ISEKI Technical Information

Inf. Nr. : PI 2014-23
Date : 5/26/2014

PRODUCTS:	SMM54-SXG22E4
SUBJECT:	Modification of SMM54-SXG22E4 to comply with the France safety regulation.

1. Description

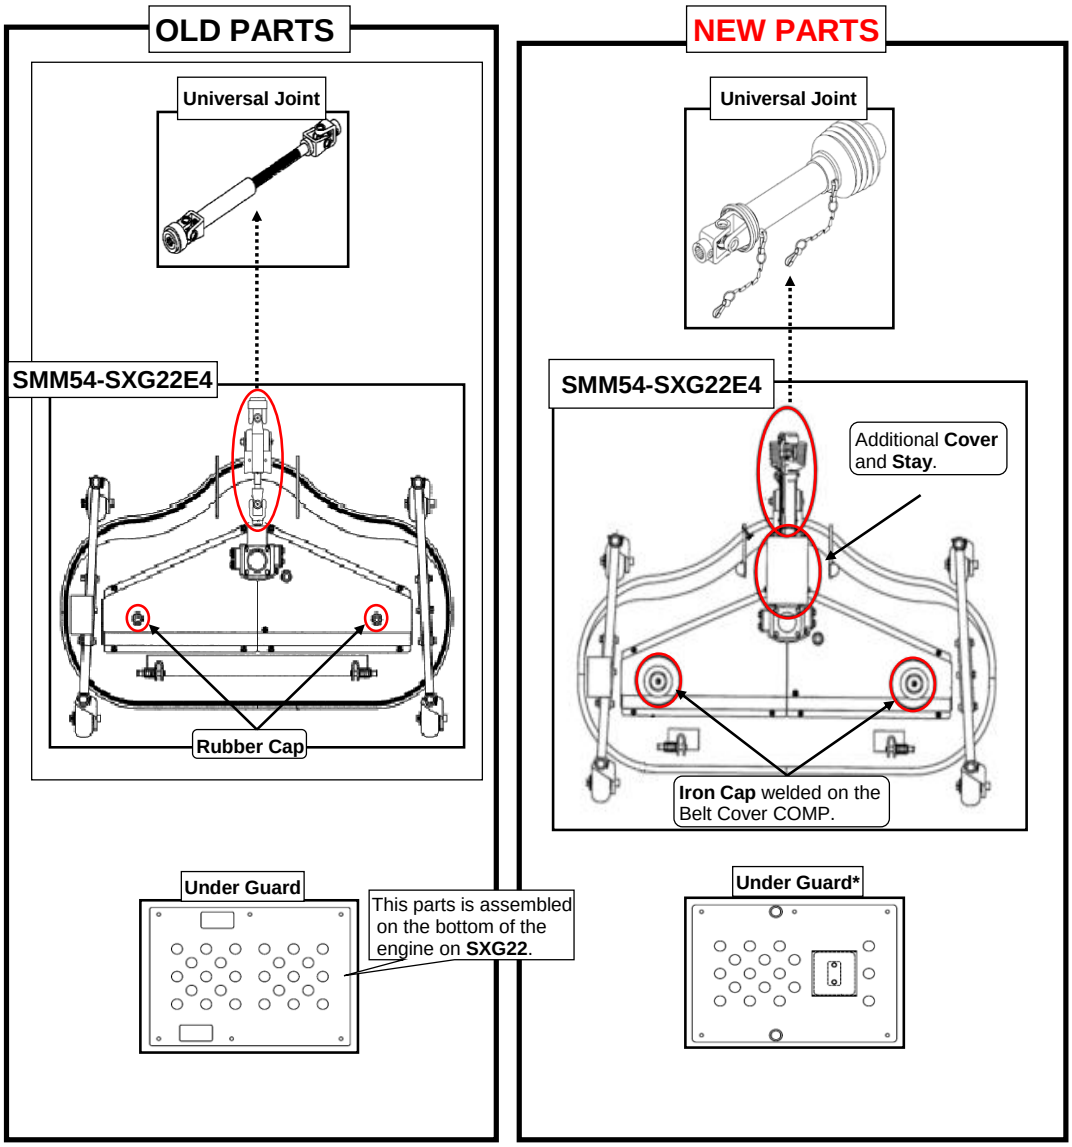
*When installing new type of **SMM54-SXG22E4**, use new **Under Guard**.

To comply with the France safety regulation (Phase 2), **SMM54-SXG22E4** was modified as mentioned above.
